Main Street Reconstruction and Beach Areas 1 & 2 Revitalization Class Environmental Assessment - Addendum

PUBLIC OPEN HOUSE

May 30, 2024

OVERALL FUNCTIONAL PLAN - ADDENDUM

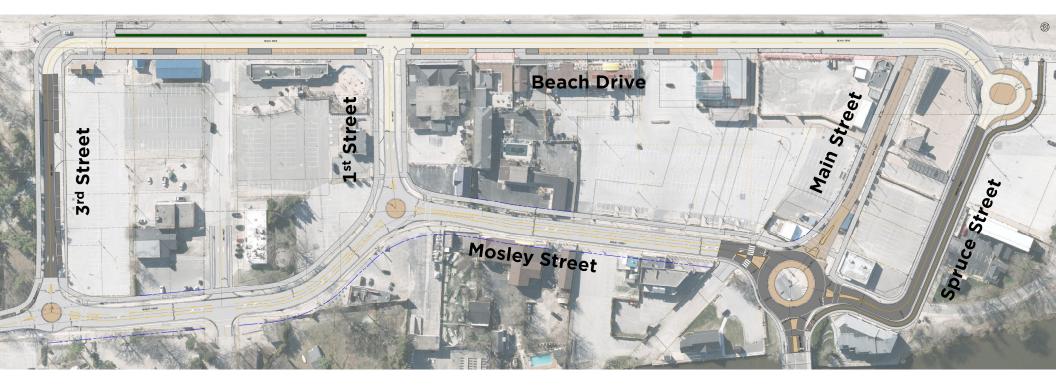
- New development partner FRAM Building Group
- Based on public feedback, Council passed Resolution JCAC-277-2023, approving the re-opening of the Class EA to allow vehicles on Beach Drive
- Redevelopment proposal limits the property available for Beach Drive (reduced to 22.1 m from 27.5 m).
- Property restrictions due to the inability to acquire two properties along Beach Drive (right-of-way reduces to 18 metres on an interim basis until further widenings can be obtained)
- Due to the redevelopment proposal, access to Main Street properties may be interrupted. This would require Main Street to be opened to local traffic
- With the opening of Main Street and Beach Drive to vehicular traffic, the intersections along Mosley Street require re-evaluation

BEACH DRIVE – REVISED SECTION WITH PARKING

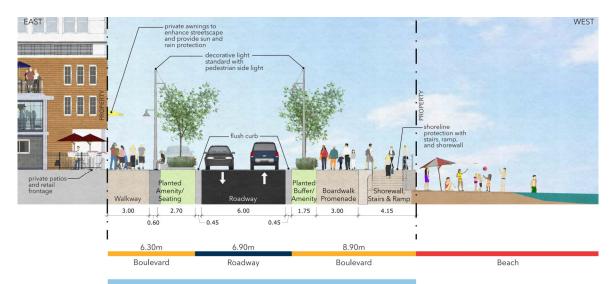
Road is essentially being re-built in its existing location with enhancements to landscaping and pedestrian access.

- 3.0 metre walkway along the commercial frontage
- 3.3 metre amenity strip to accommodate street furniture, street lighting, and plantings or parking zone
- 6.0 metre wide road with 0.45 metre flush gutters on both sides
- 1.75 metre planted buffer/amenity area
- 3.0 metre boardwalk promenade
- 4.15 metre zone for shore walls and ramps/stairs for beach access or seating lookout area
- "flexible street" that can be easily converted to special event space

BEACH DRIVE – REVISED SECTION AT PINCH POINTS

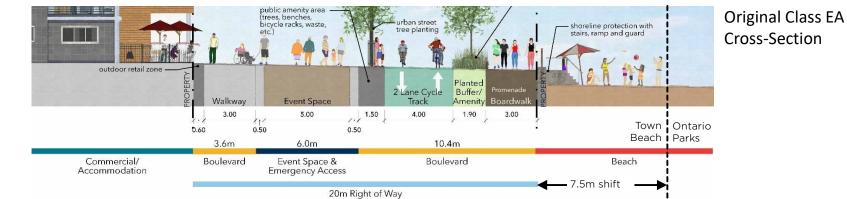
- maintain existing 18m ROW
- no on-street parking
- no planted amenity/seating area
- reduced storefront sidewalk

Removal of Cycle Track

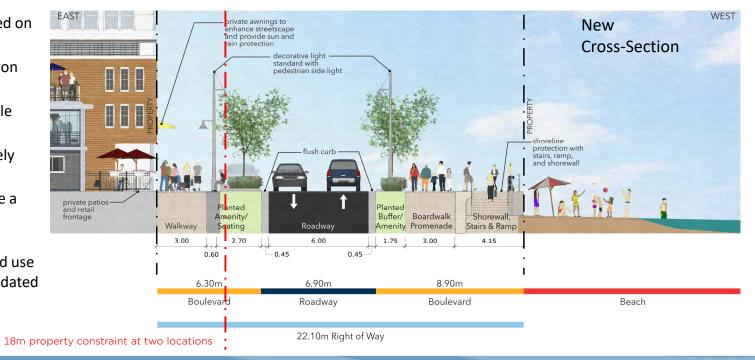
- overall capital infrastructure costs are significant and viability of project hinged on reducing costs
- additional cost for land and expropriation requirements
- unable to accommodate within available property
- previous Class EA section required timely private land acquisition
- dedicated cycle track may have become a secondary pedestrian corridor in the absence of enforcement
- Beach Drive will be low speed so shared use with 'road bike' users can be accommodated should they choose not to use the boardwalk

Opening of Main Street

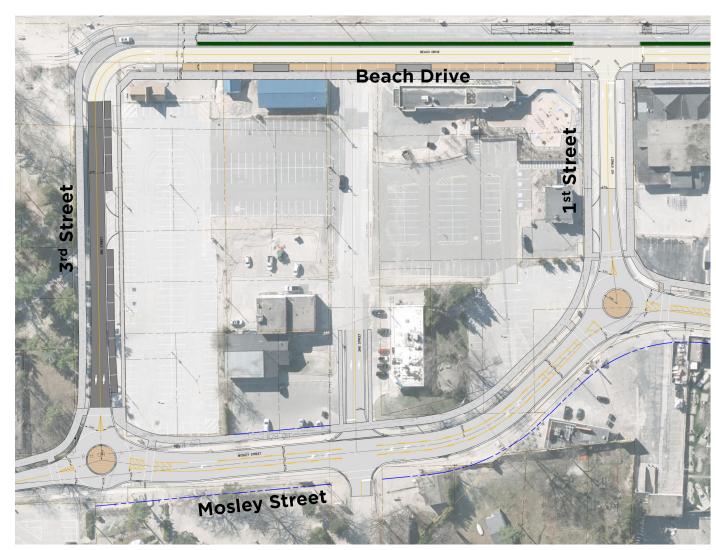
Due to the redevelopment of the area, vehicular access to internal lots along Main Street may be interrupted. This will require new access granted directly from Main Street which will require Main Street to be opened to traffic.

The intent is for Main Street to be a pedestrian-first corridor, with vehicles limited to delivery vehicles, property owners, and other critical users required to access the adjacent lots. Through signage, road geometry, and other design features, the general public will be discouraged from entering Main Street, which will be designed to promote low speeds and low volumes.

Main Street will be a "flexible street" that will promote pedestrian needs over vehicles, contain flush curbs, and easily convert to special event space.

A fourth leg at the north end of the Mosley Street roundabout will be required for access.
